## HORSHAM DISTRICT COUNCIL CONSULTATION

<b>TO:</b>	Horsham District Council – Planning Dept
<b>LOCATION:</b>	Land To The North and South of Mercer Road Warnham
<b>DESCRIPTION:</b>	Redevelopment of the site to provide 304 residential units, parking, a retail unit, public car park, public open space, attenuation basins and landscaping
<b>REFERENCE:</b>	DC/25/0151
<b>RECOMMENDATION:</b>	Modification / More Information

Appendix 2: Proposed Masterplan UKHab Classification

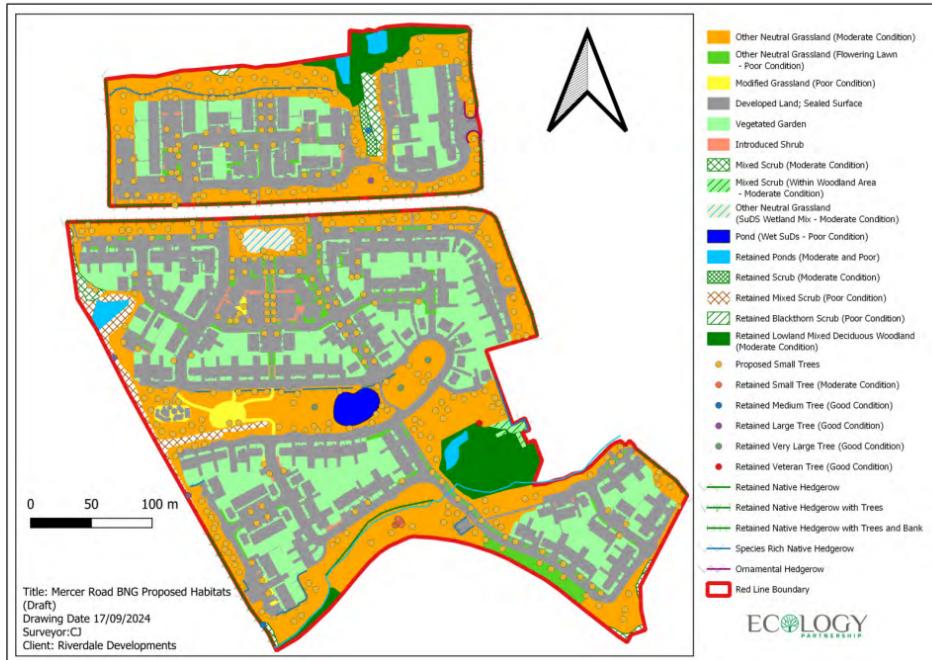
3.9997ha of other neutral grassland to reach 'moderate condition' is proposed 'around the site boundaries sensitively managed for wildlife and biodiversity'. From looking at the post-development habitat map in the BNG report, this is almost the rest of the green space in the site (orange colouring on the map below, Appendix 2 of BNG Report).

I have concerns as to the level of damage that potential recreational use may have on these areas, particularly in the open space areas surrounding the wooded stream, priority woodland and in the ancient woodland buffer area where clearly mown pathways, post-and-rail fencing / green barriers and signage are absent. It is my opinion that not enough modified grassland / amenity area such as that in the central island of the site (yellow colouring on the map above) is provided to alleviate this pressure on areas of other neutral grassland (sewed for biodiversity purposes). I also believe, given their open space nature and close proximity to the dwellings, these areas will be used recreationally, and I therefore question whether Criterion A (essential for other neutral grassland to reach moderate condition) will be met.

The area of modified grassland in the central 'island' of the site is very small. The immediate surrounding area is marked as other neutral grassland to reach moderate condition. It is considered probable that the surrounding areas of the allocated modified grassland for the open space area will also be used recreationally, and it is therefore advised that at least half of this island is sewn as modified grassland and dedicated to recreation.
